Re: VAI Response to Traffic Engineering Peer Review
Town Yard Redevelopment
Andover, Massachusetts

Vanasse & Associates, Inc. (VAI) is responding to comments that were raised in the January 25, 2024 *Traffic Engineering Peer Review* letter prepared by The Engineering Corp (TEC) concerning their review of the November 9, 2023 *Transportation Impact Analysis* report that was been prepared by VAI in support of the proposed town yard redevelopment to be located in Andover, Massachusetts (hereafter referred to as the “Project”). Listed below are the comments that were identified by TEC in the subject letter that pertain to the November 9, 2023 report and require a response, followed by our response on behalf of the Project proponent.

Figure AT-2
 Andover Fire Truck Turning Analysis
 Entering from Lewis Street and
 Exiting to Pearson Street

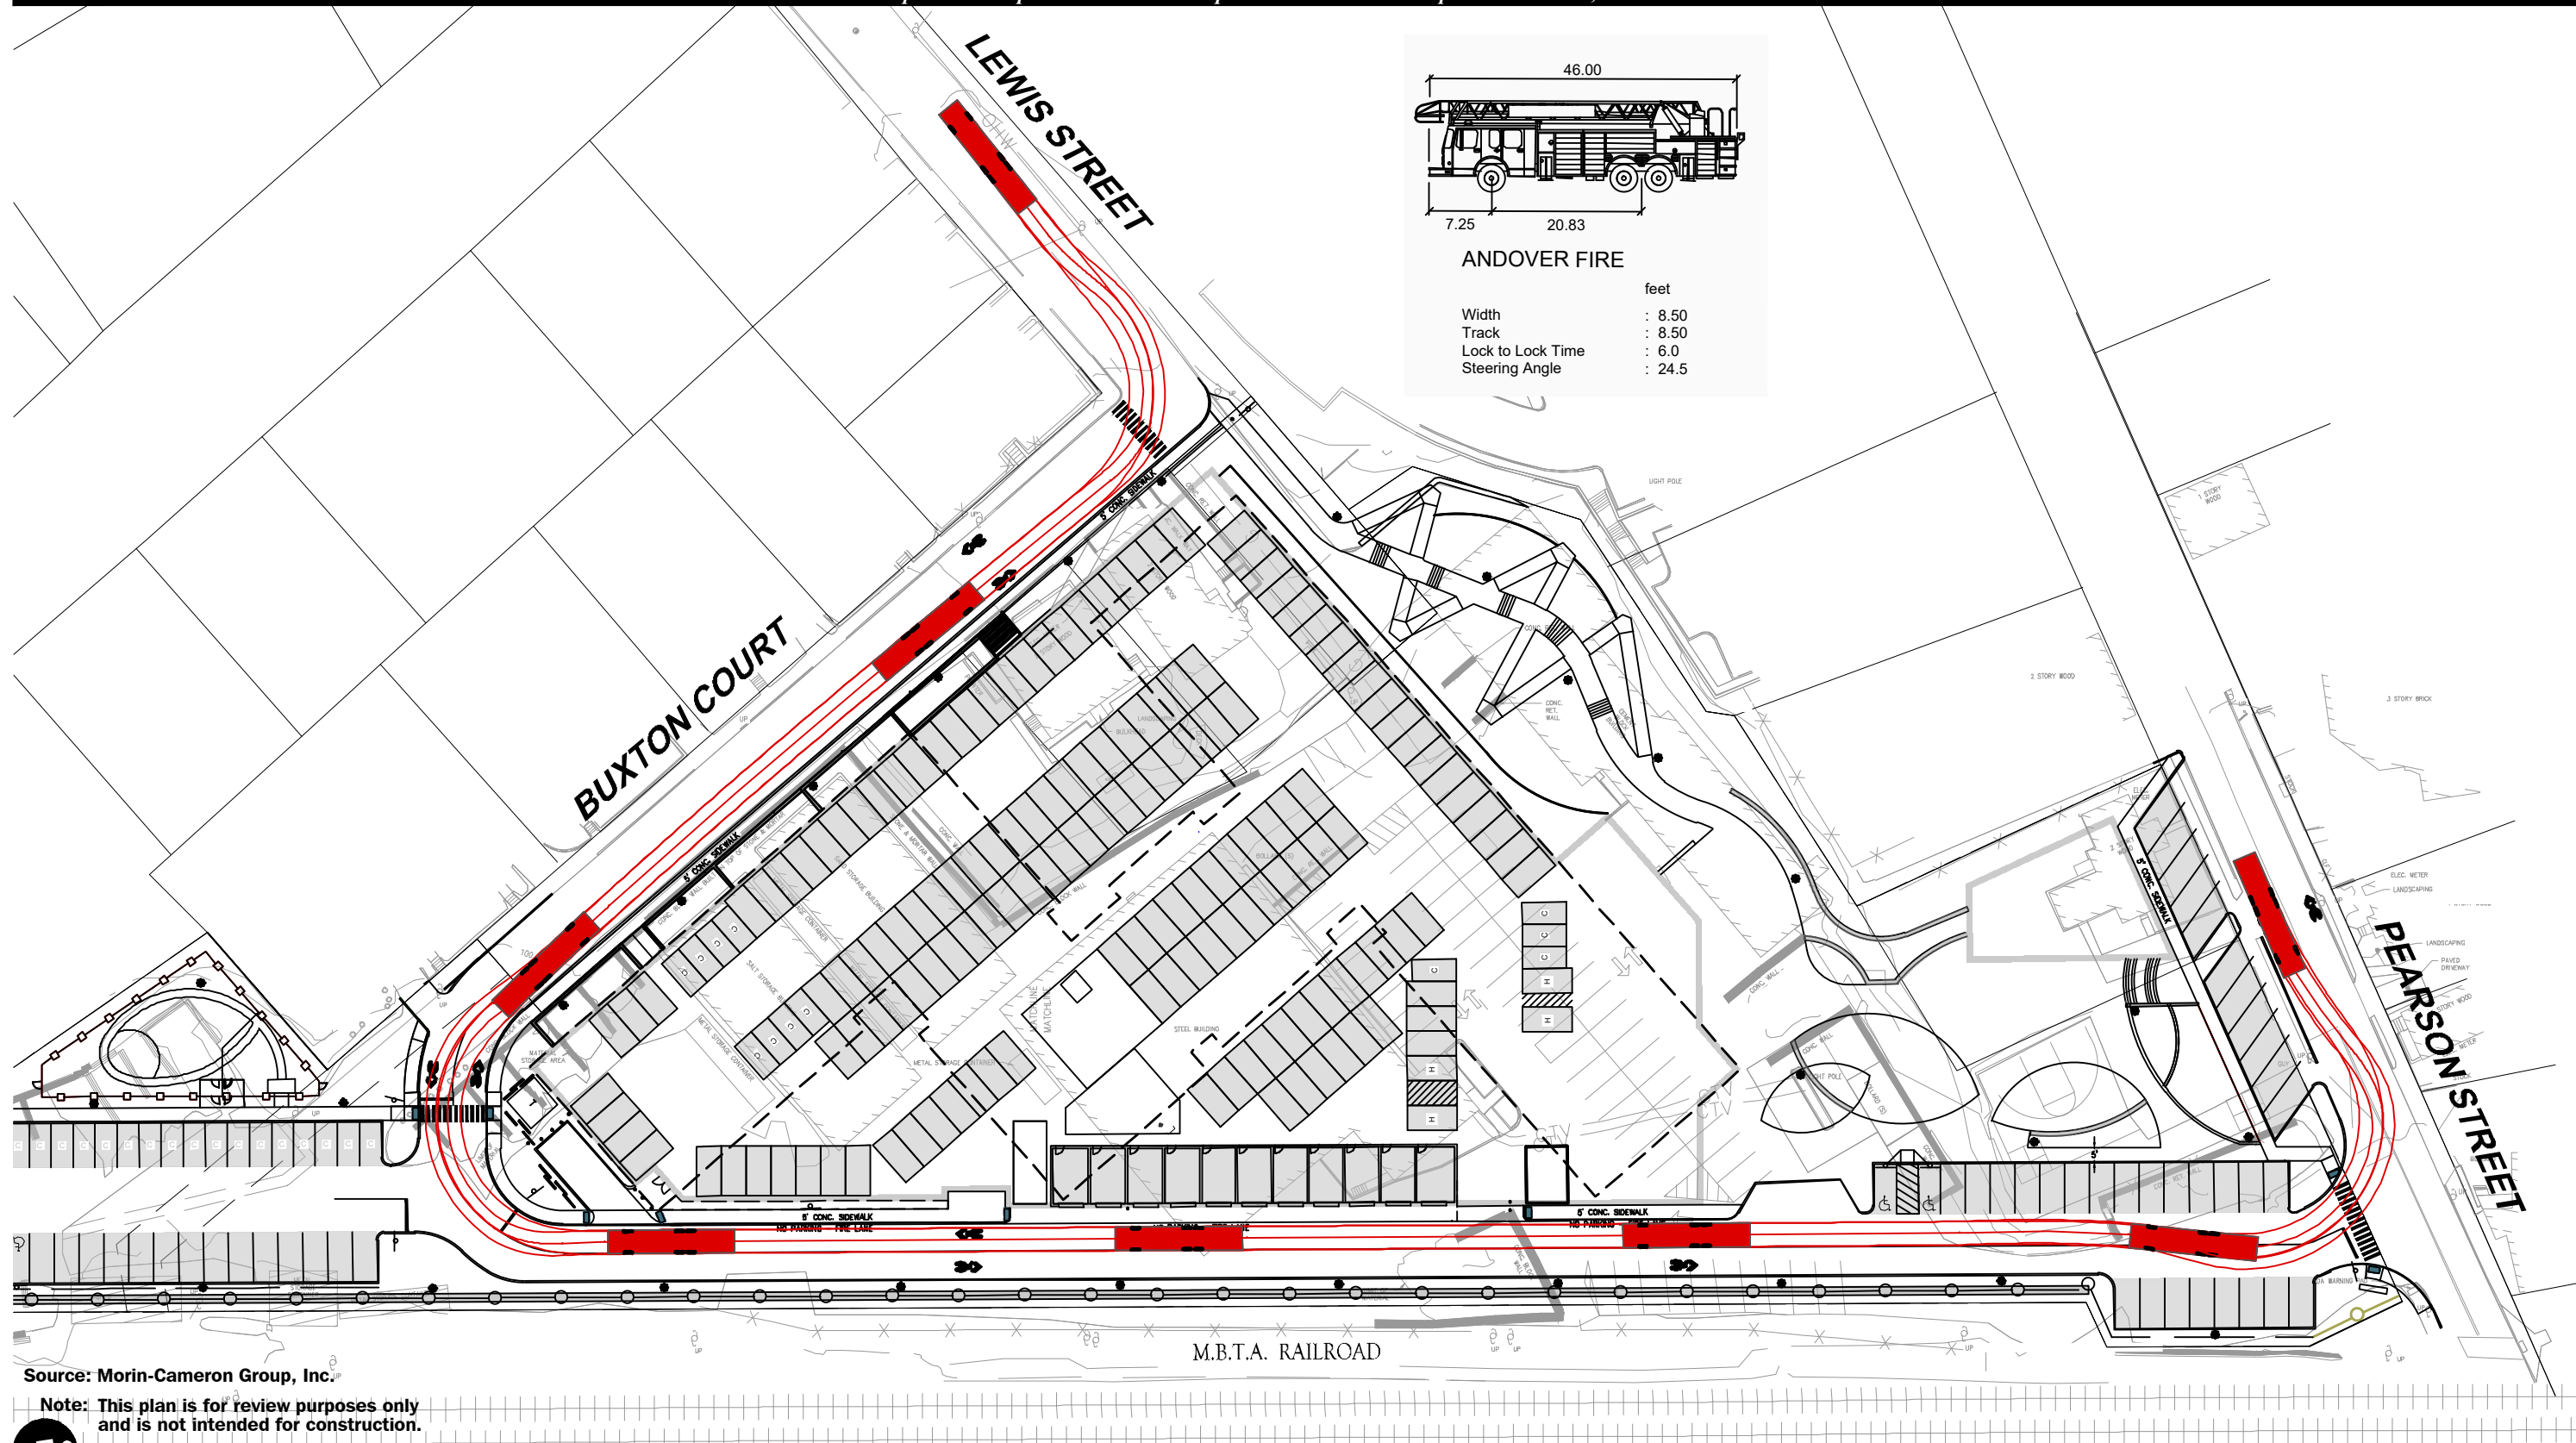
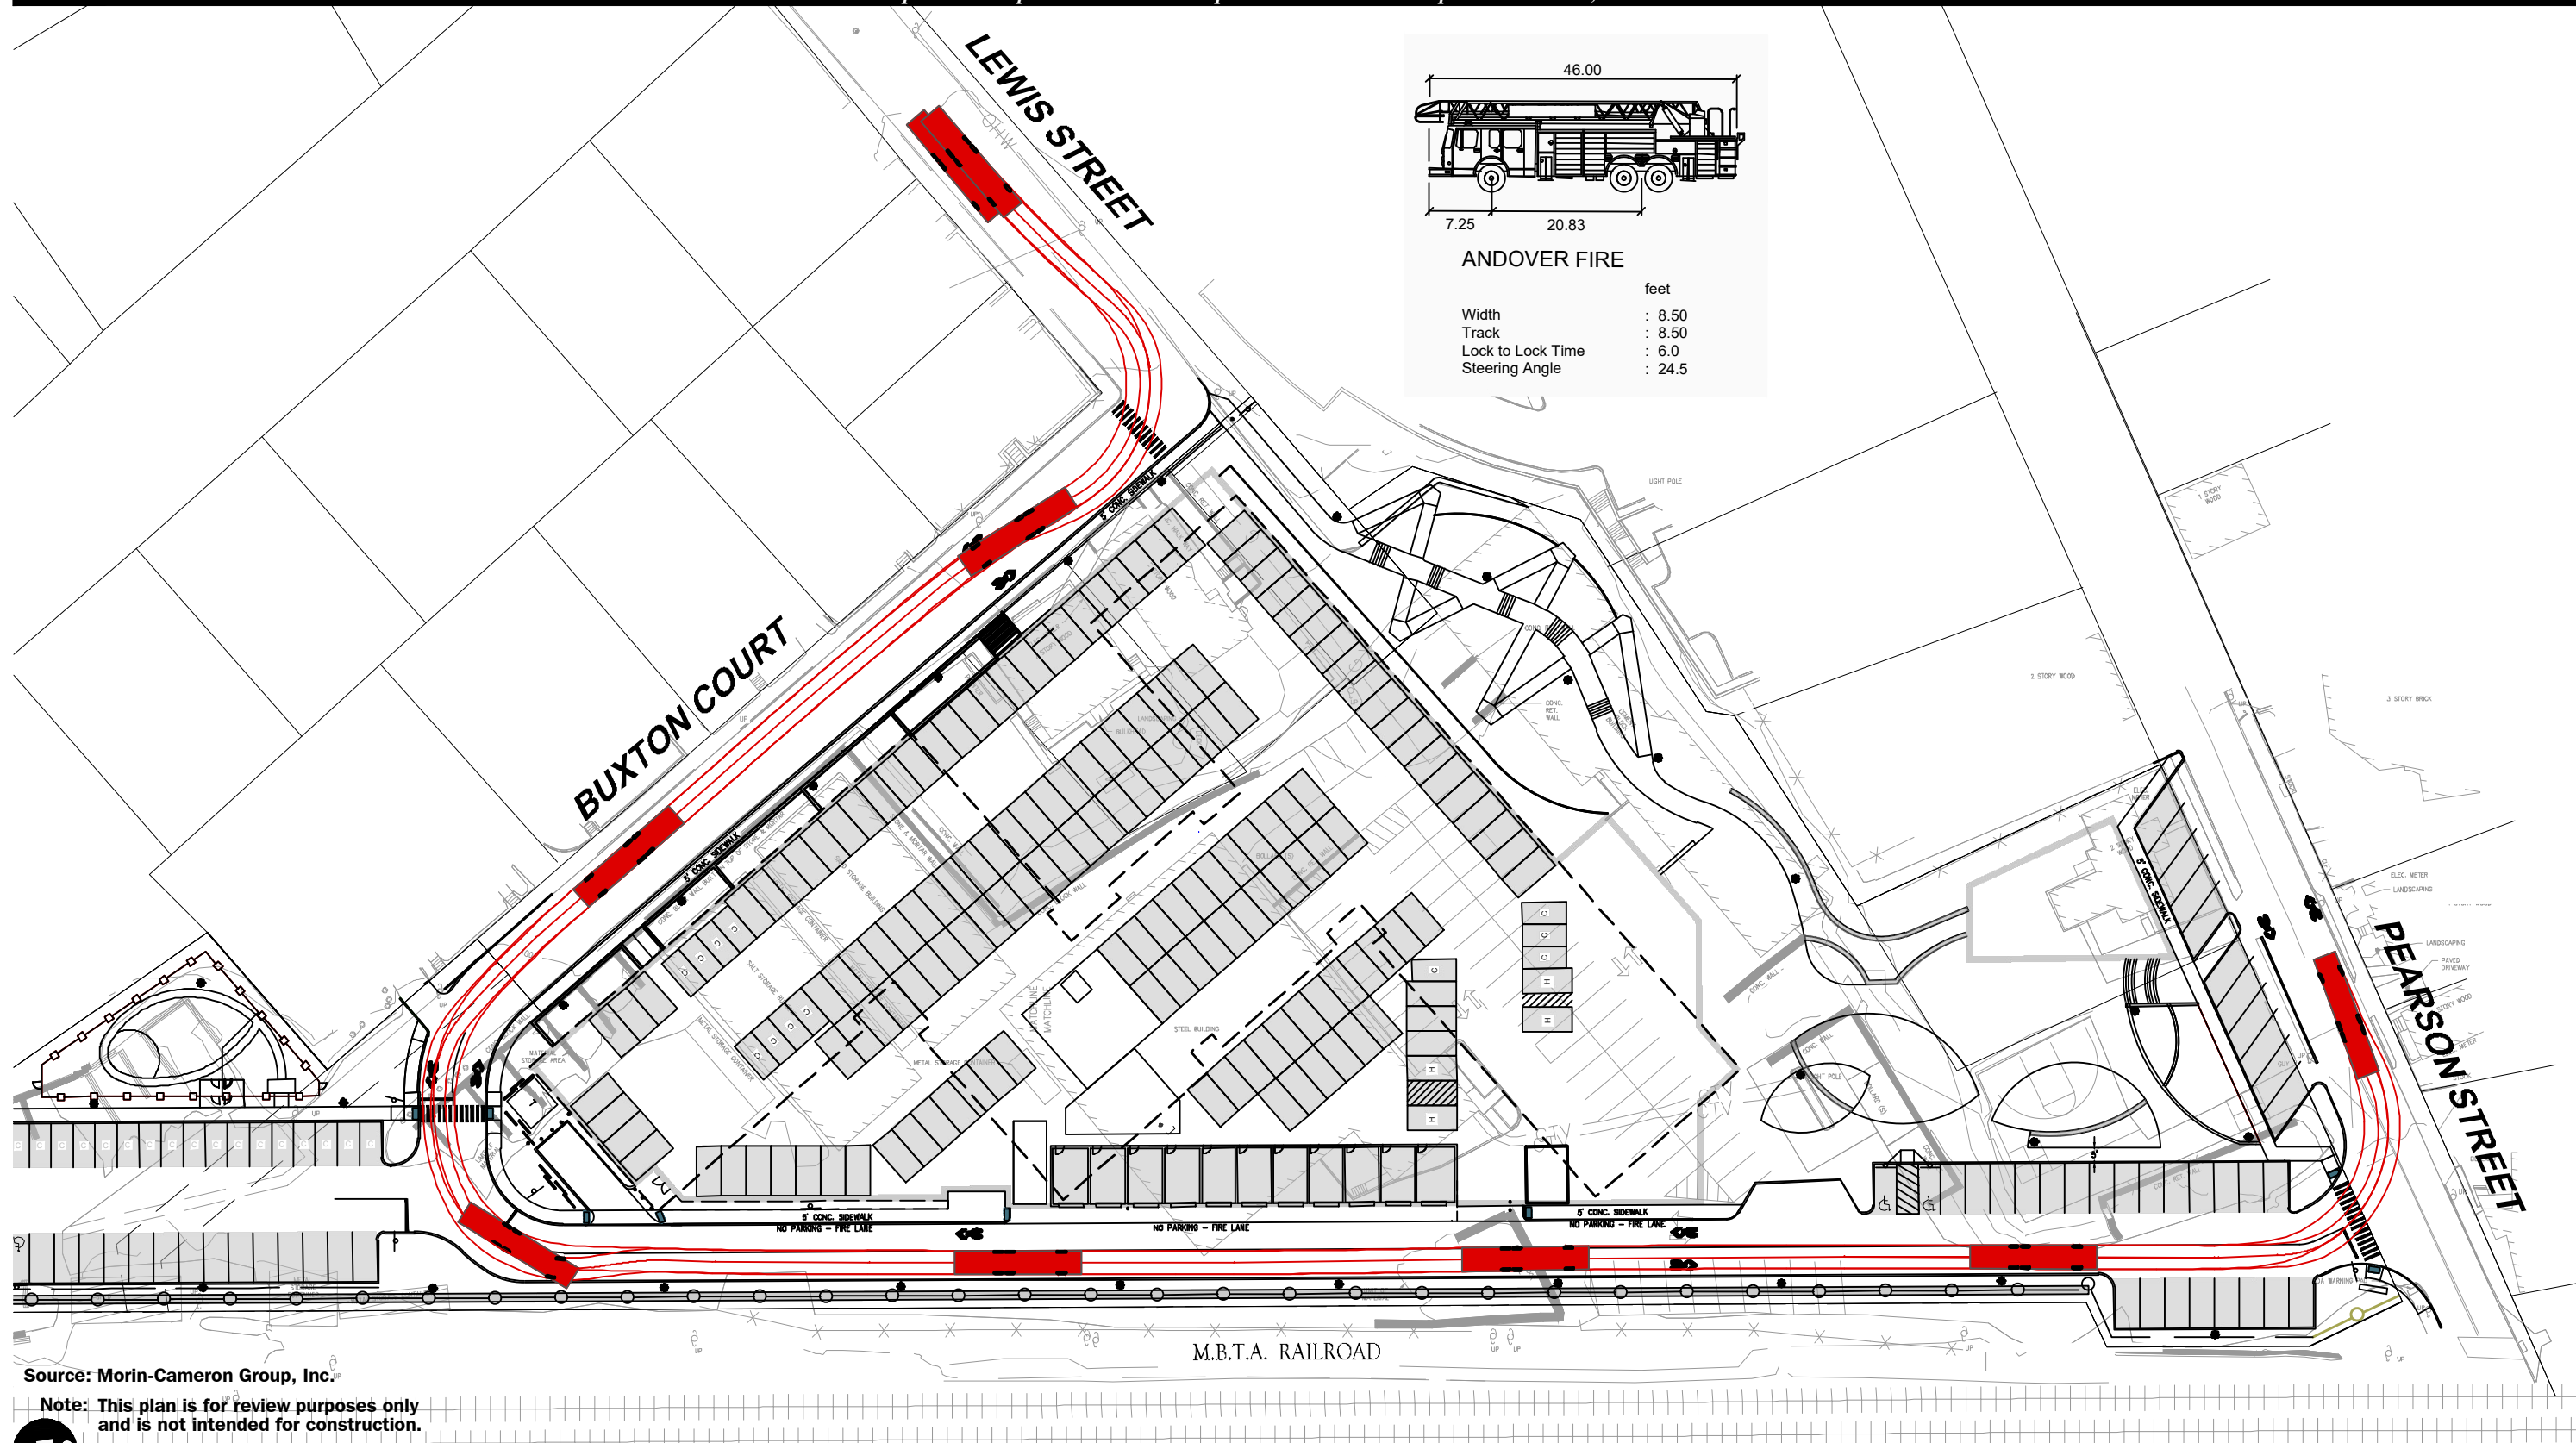
Comment 32: *The Applicant has provided an Auto Turn Exhibit showing the Andover Fire Ladder Truck currently housed at the Central Fire Station. The exhibit shows the apparatus entering, circulating the site, and exiting through both driveways. The vehicle can enter and exit both access points and circulate the internal roadway; however, there would be encroachment into opposing travel lanes at the access points and internally at the northwest corner of the site. TEC defers to the Town of Andover Fire Department to verify whether the dimensions of their fire trucks match the dimensions used in the turning analysis.*

MC Response: Lt. Ryan T. Beal, Fire Prevention Officer for Andover Fire Rescue indicated on March 6, 2024 in an email to Leticia Oliveira of MC that the swept path analysis is acceptable.
